DevHU0202: Lincolnshire Lakes

Case ref:	DevHU0202	Document ref:	TM07	Date issued:	03/10/2025
Prepared for:	Simon Geoghegan	Prepared by:	Roxana Watson	Reviewed / approved by:	Terry Dale

Headline Summary

Figure 3. Updated M180 J3 Development Flows (BWB) ³

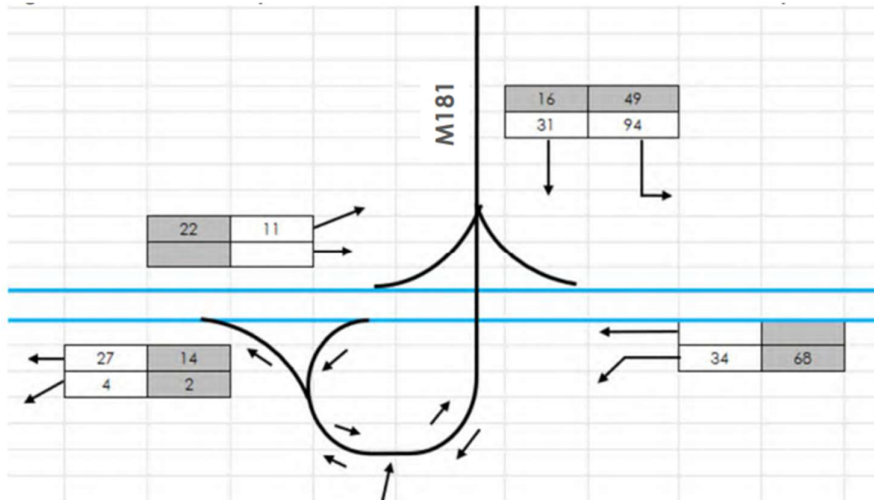
- 9% more vehicular traffic routing through M180 Eastbound, from 3.5% to 12.5%.
- 4.5 BWB has now taken into account the aforementioned traffic distribution difference and provided updated traffic distribution diagrams, as presented in **Figure 3**. The traffic distribution previously proposed (TA) is presented in **Figure 4**.

- 4.6 As illustrated in **Figure 3**, BWB now forecasts that a total of 94 vehicular trips are expected to travel eastbound through M180 Junction 3 during the AM peak hour from the proposed development, and 49 vehicular trips during the PM peak hour.
- 4.7 BWB states that the merge / diverge assessments have also been updated, with **Table 1** providing details of the analysis. The JSJV observes a discrepancy between the base year indicated in the table (2027) and the base year stated in the main text of the TAA (2036). Furthermore, **Table 1** does not reflect the updated trip distribution referenced by BWB in the main text of the TAA.

Figure 5. Personal Injury Collision Records 2018-2019 and 2022-2024⁸

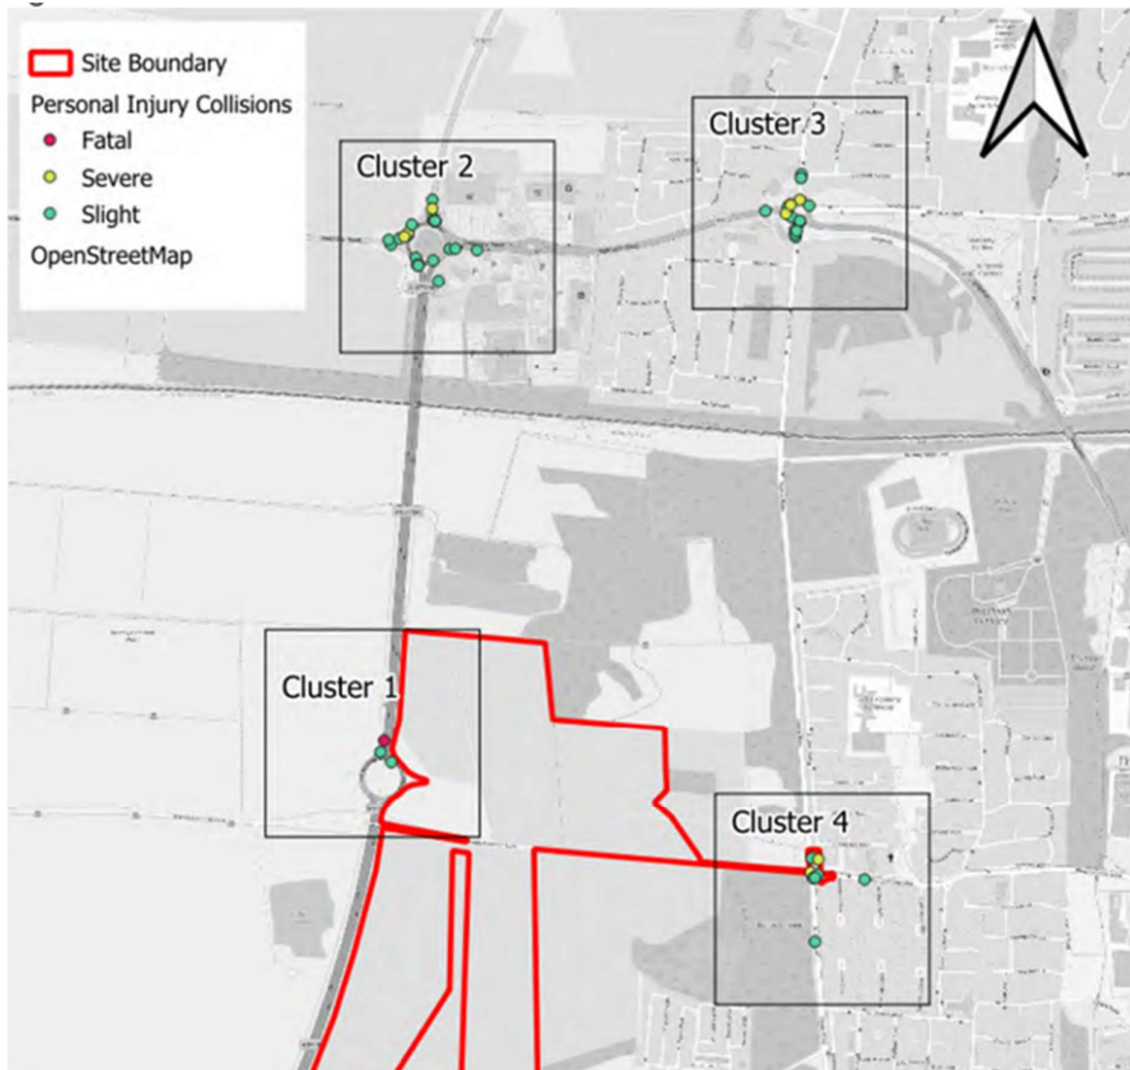
- 4.17 BWB notes that one fatal collision occurred on 24th February 2023 at 21:45 at the M181/A1077 roundabout, within the vicinity of the site access. The incident is noted to involve a car losing control and crashing into a barrier due to aggressive and reckless driving. There were two reported casualties, one fatal and one serious. The road surface was wet/damp, but the collision was attributed to driver behaviour rather than road design.

- 4.18 Furthermore, BWB notes four collision clusters, as presented in **Figure 5**.
- 4.19 As shown, the first cluster is located at the M181/A1077 roundabout, and includes:

- One fatal collision in 2023 (previously discussed); and
 - Two slight collisions, both occurring in 2022.
- 4.20 BWB concludes that there is no highway safety concern at the proposed site access roundabout where cluster 1 is located, that could be exacerbated by the development proposals. The JSJV agrees with this conclusion.

- 4.21 The second, third and fourth clusters are located at the A18 Doncaster Road/A1077 roundabout, the A18 Doncaster Road /Scotter Road/Doncaster Road/A18 Kingsway roundabout and the Scotter Road/West Common Lane/Brumby Common Lane junction. However, as these junctions fall under the authority of the Local Highway Authority, the JSJV will not provide any comments on the PIC data for these locations.
